**Re: Hans Wittler Automotive, 121 Elizabeth St.
90-Day Temporary Certificate of Occupancy- Transportation Development**
Architect's Stamp dated 03-05-14 (K21-D034)
Certification dated 06-26-14

Re: Wittler Automotive, 121 Elizabeth St. NE

TRAFFIC CERTIFICATION

SHEET TITLE:
SITE PLAN

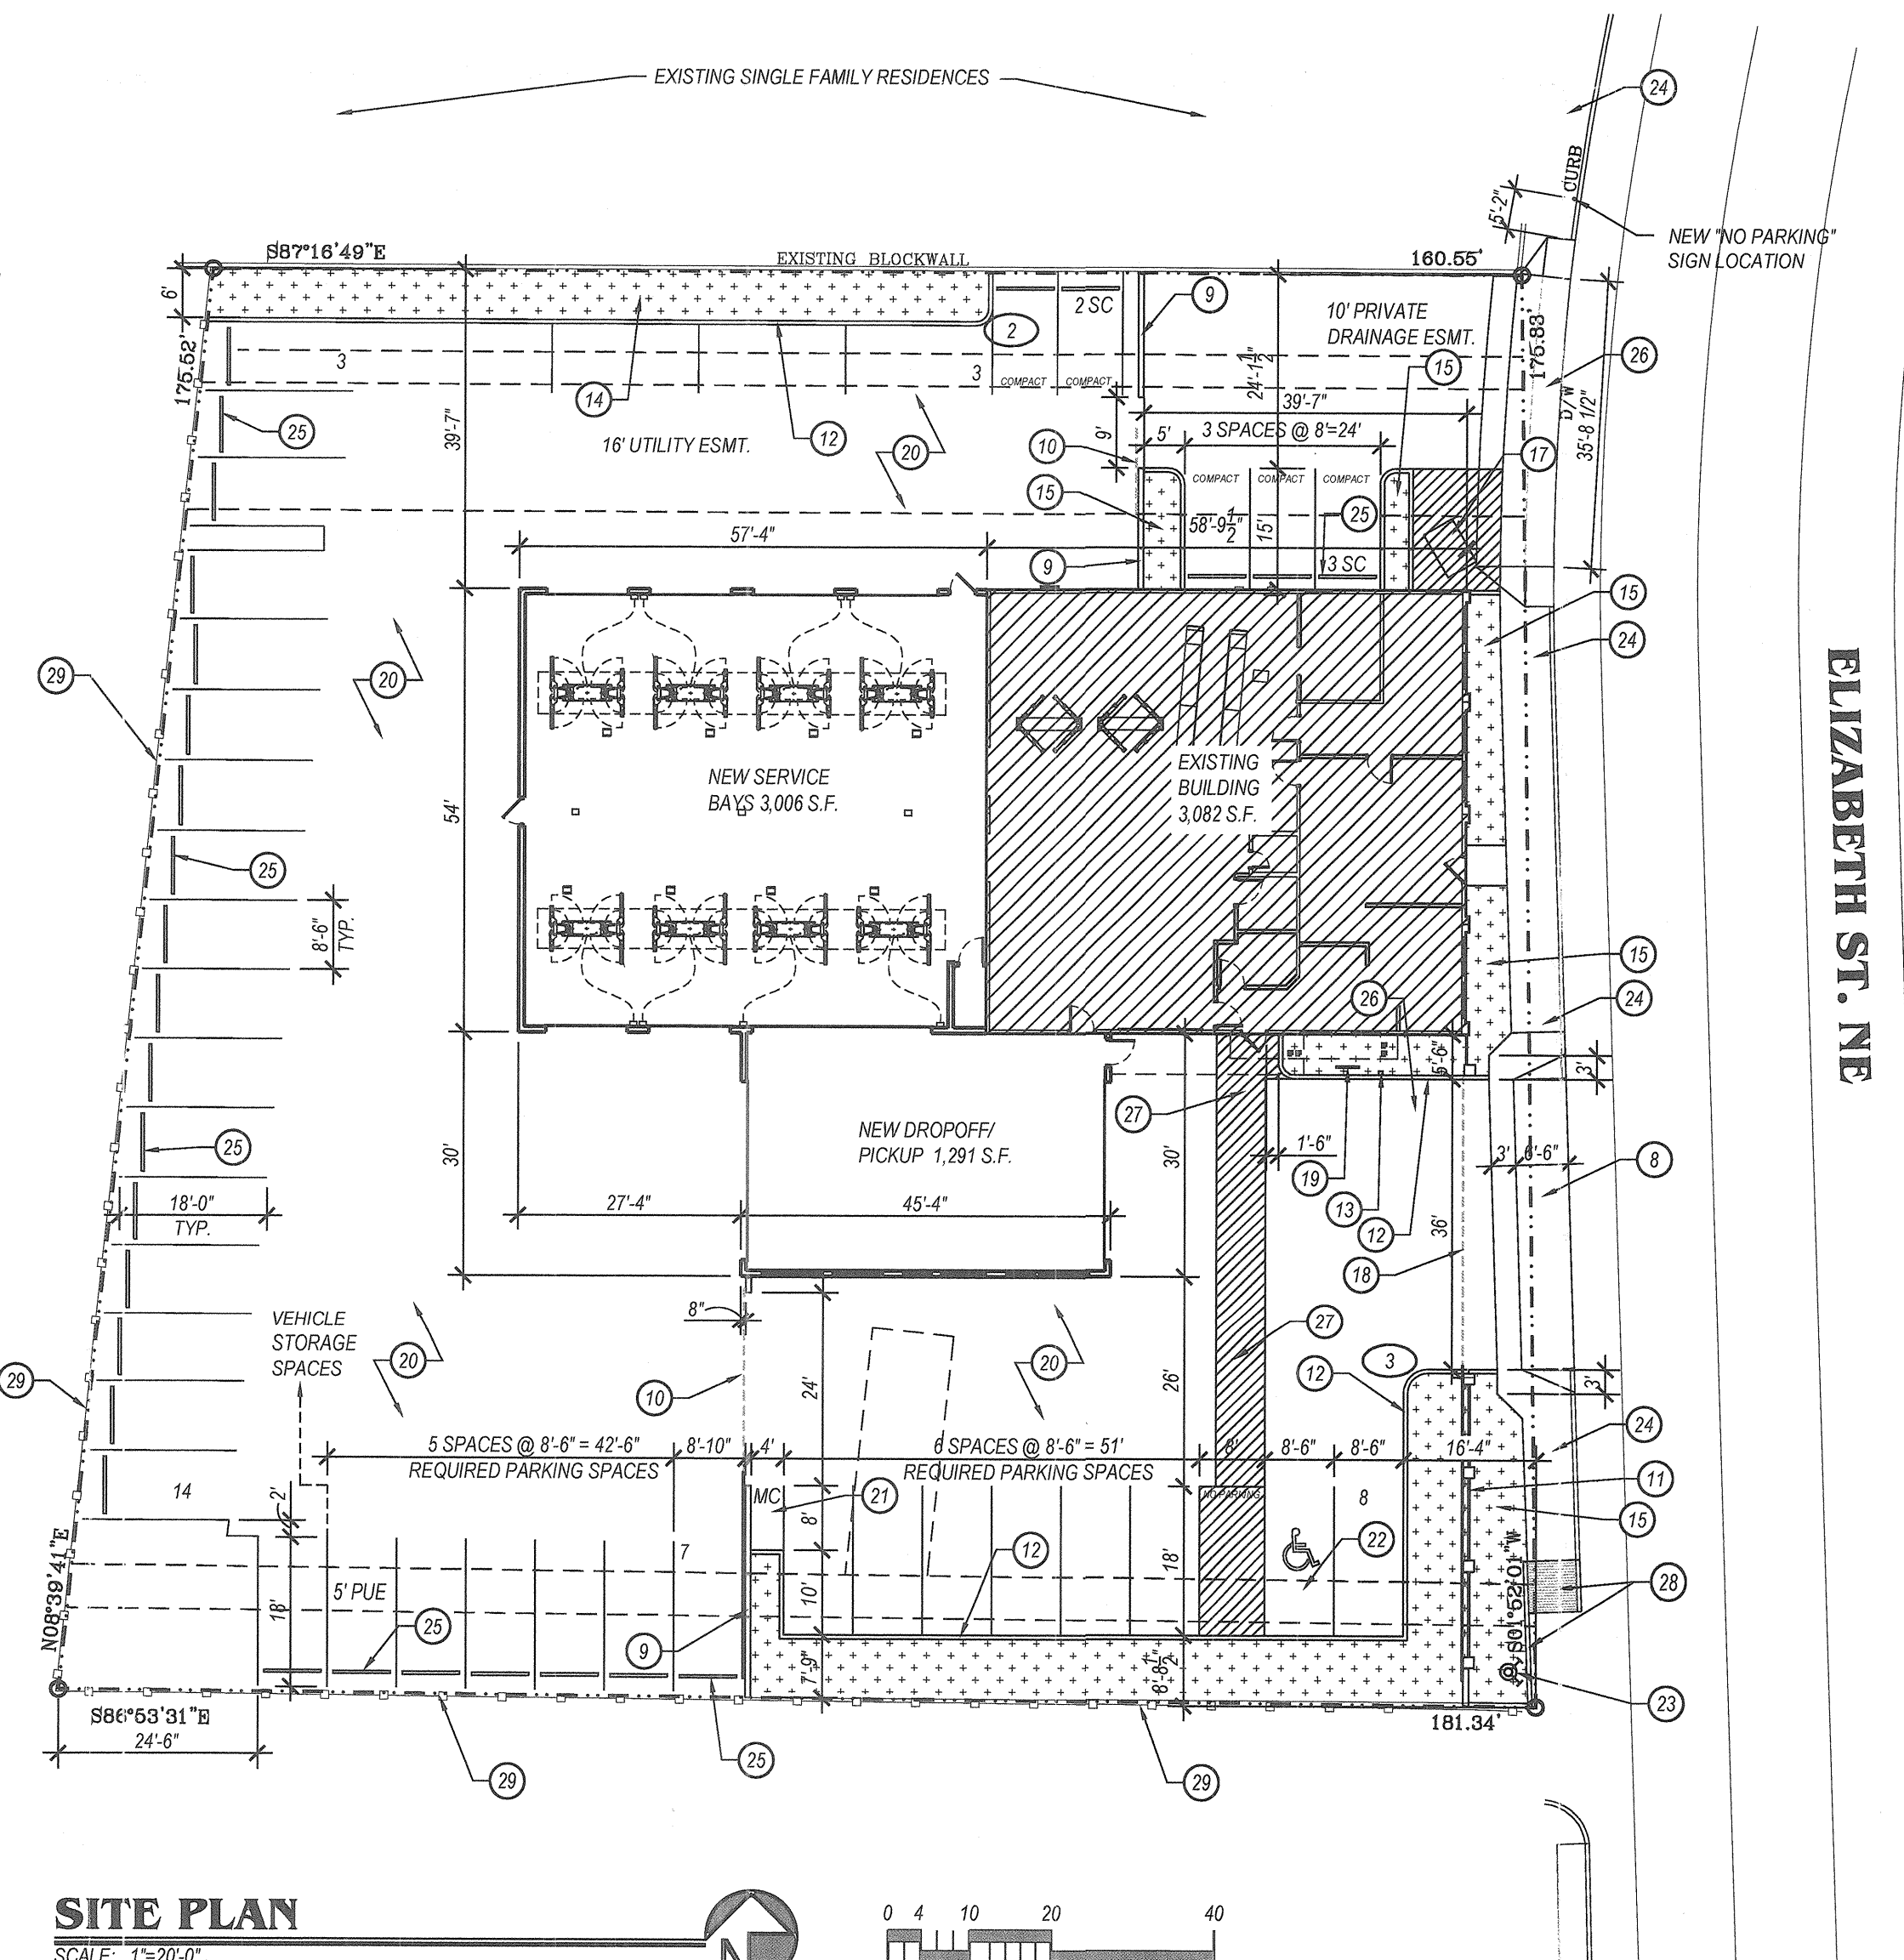
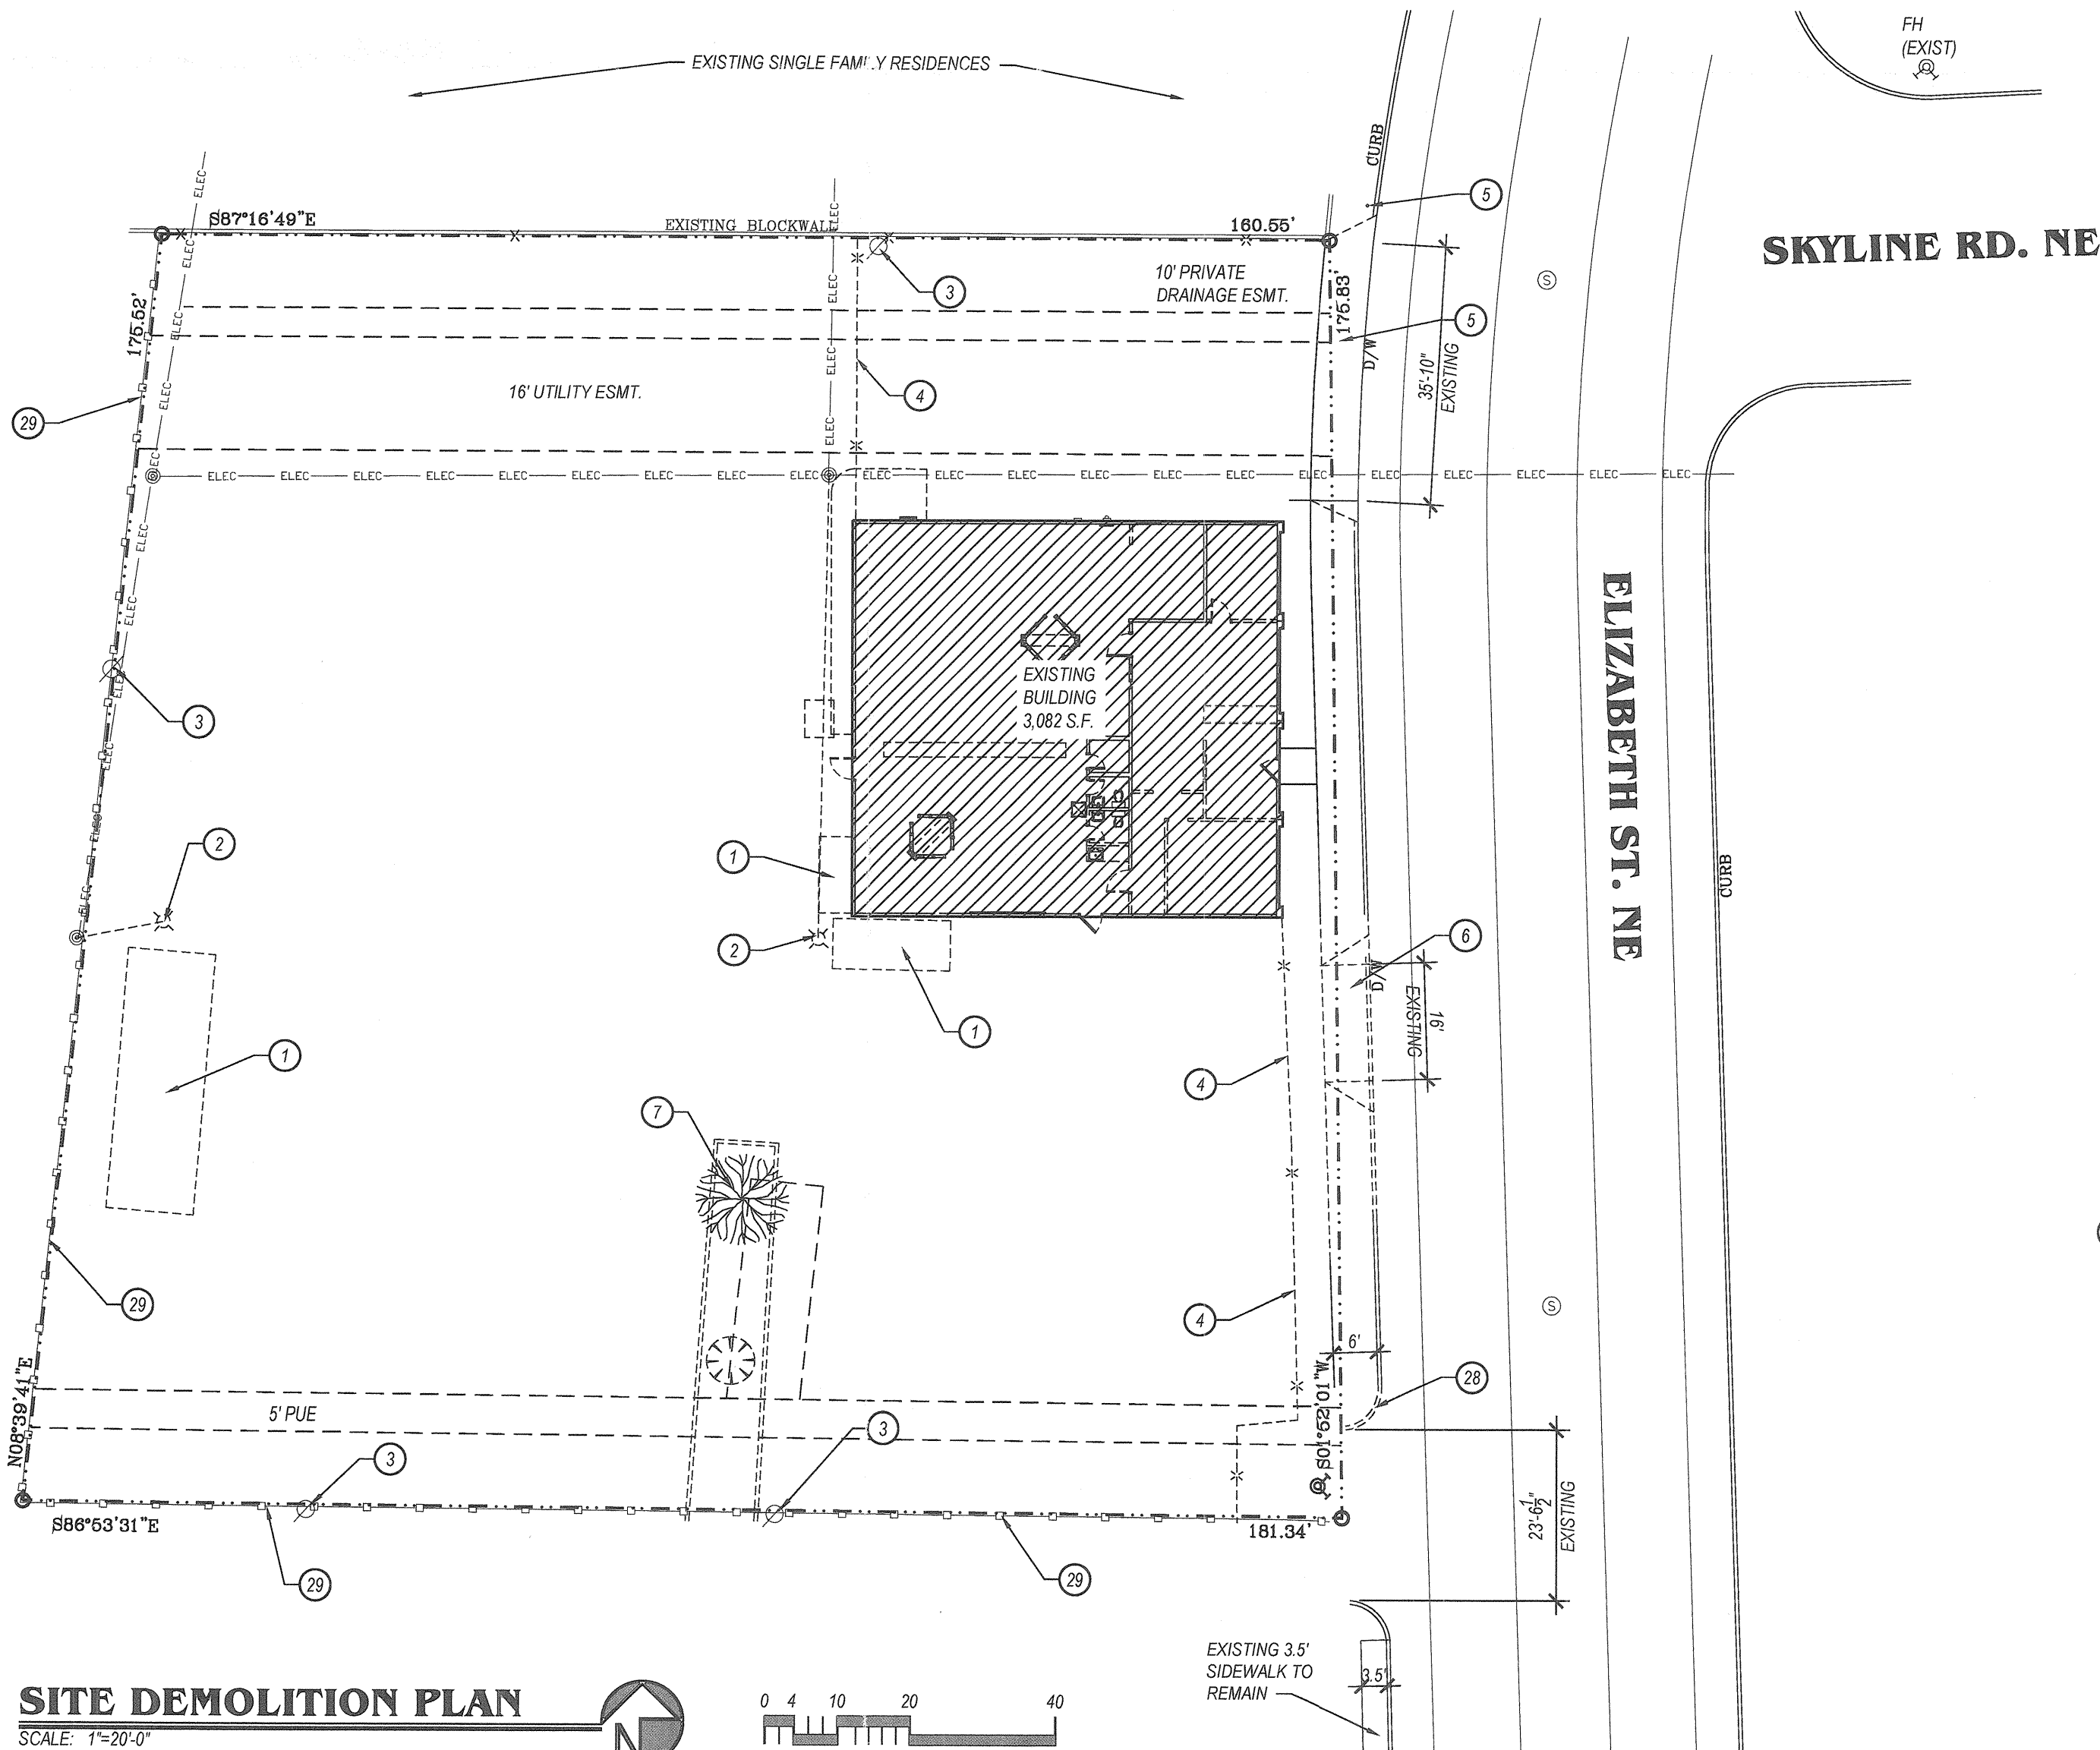
- As requested in your TCL approval letter, please provide a Permanent Sidewalk Easement.

- 1. The parking bumpers for the vehicle storage spaces have been removed.*
- 2. The interior gate at the SW corner of the New Dropoff/Pickup has been deleted. The fence and gate at the street was increased in height as per the Zoning requirement. This change was discussed with David Kirkpatrick with Zoning.*
- 3. The new Fire Hydrant shown in the SE corner of the site was not installed. This change was approved by the Fire Marshall.*
